Submissions Report

Burroway Solar Farm

Kleinfelder Document: **NCA25R177858**

Prepared for:
Edify Energy

FIGURE:
3

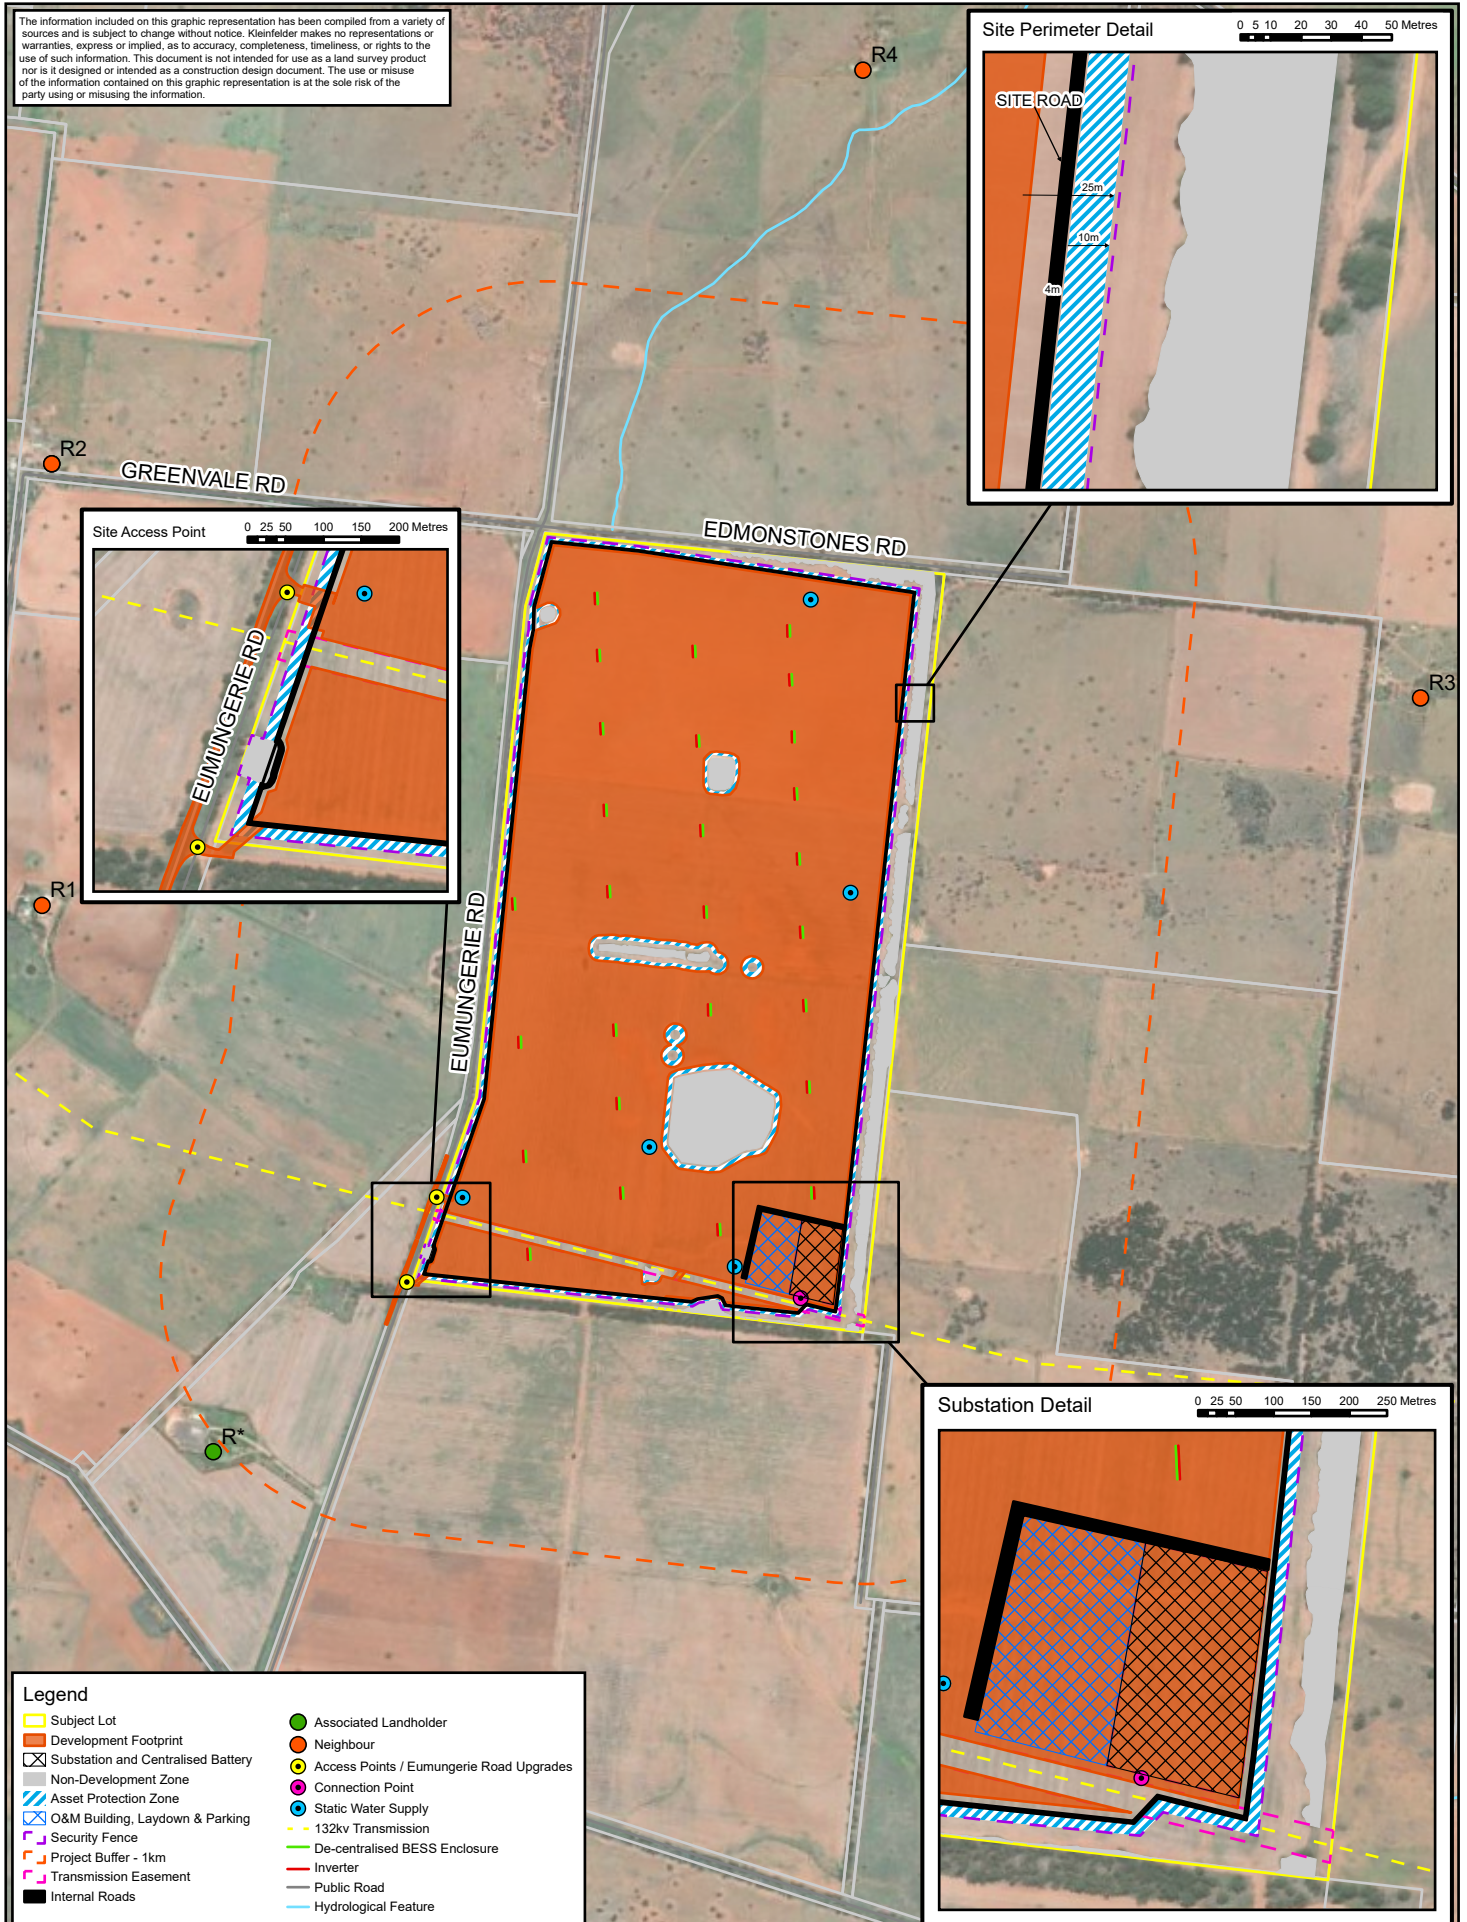
The EIS does not include plans for proposed structures, nor appropriate site plans, with buildings or transportable structures shown. The EIS mentions future applications for construction certificate would also be needed. The developer should consider that in accordance with s19 of the *Environmental Planning and Assessment (Development Certification and Fire Safety) Regulation 2021*, a certifier must not issue a construction certificate for building work unless the design and construction of the building, as described in the relevant building work plans and specifications, is consistent with the development consent. Consideration should be made as to whether further development applications are sought, or additional details of the proposed building work is provided.

Edify acknowledges NSW RFS comments and has amended the project BFAR (**Appendix G**) in response, as well as the project infrastructure layout (**Figure 3**) to clearly illustrate firefighting asset locations including water tanks. The BFAR was updated both in response to the NSW RFS submission and to further align the project with best practice standards and guidelines, in particular for providing fire-fighting assets and access on the subject lot.

In response to the NSW RFS submission during the public exhibition, the project site layout figure was updated to clearly illustrate fire-fighting asset locations, including the location of five 45,000 litres (L) water tanks as shown in **Figure 3**. This update has not resulted in a change to the overall project footprint; however it is a refinement of the site layout and infrastructure for firefighting resources as the original BFAR only provisioned one 20,000 L static water supply for firefighting purposes to be available on site at all times.

Figure 3 of this submission report illustrates this minor refinement to completely excise the mapped category 2 sensitive regulated land in the central southern extent of the subject lot, including application of a 10 m APZ within a 30 m buffer.

- Increased capacity of static water supply available on site dedicated solely for fire-fighting purposes. As discussed in Section 3.4 of the amended BFAR (**Appendix G**), five tanks with 45,000 L capacity have been recommended in strategic locations throughout site (**Figure 3**). This update aligns with Chapter 4.2 of the Victorian Country Fire Authority (CFA) document *Design Guidelines and Model Requirements Renewable Energy Facilities v4* (2023). NSW RFS will be consulted on the proposed amount and location water supply during detailed design to ensure it is appropriate for the site.

The centralised BESS will be located next to the substation in the south-east corner of the subject land as demonstrated in **Figure 3**. The current placement of the potential centralised BESS design within the south-eastern portion of the subject lot provides direct access to the centralised BESS from the proposed site accesses off Eumungerie Road (located in the south-west of the subject site), while also distancing the centralised BESS from the intersection itself (noting the hazardous potential of batteries). A 4 m wide access road will also be installed and maintained around the boundary of the substation and centralised BESS location. As illustrated in **Figure 3**, five water tanks with 45,000 L capacity each have been designated throughout the subject lot. The closest proposed water tanks for the centralised BESS option are as follows:

The de-centralised BESS configuration involves the micro-siting of individual battery enclosures alongside the inverter locations distributed throughout the solar array footprint as shown in **Figure 3**. Maintenance tracks will be installed and accessible from the primary subject site access road throughout the solar array allowing all-weather access to a potential de-centralised BESS design configuration in the event of an emergency. APZs for a de-centralised system are captured as part of solar array APZ / landscape management, with a 20 m APZ to be provided between the site boundary and the outermost batteries at minimum in line with the recommendations of the Preliminary Hazards Analysis conducted by ARUP in 2023 (Appendix N of the EIS). The five water tanks displayed in **Figure 3** will provide adequate fire-fighting resources and will be accessible for any potential fire ignition associated with de-centralised BESS enclosures.

The footprint was also updated to clearly illustrate asset locations (e.g. Water tanks) for the purposes of firefighting as well as the two proposed BAR footprints on Eumungerie Road to facilitate site access, as shown in **Figure 3**.
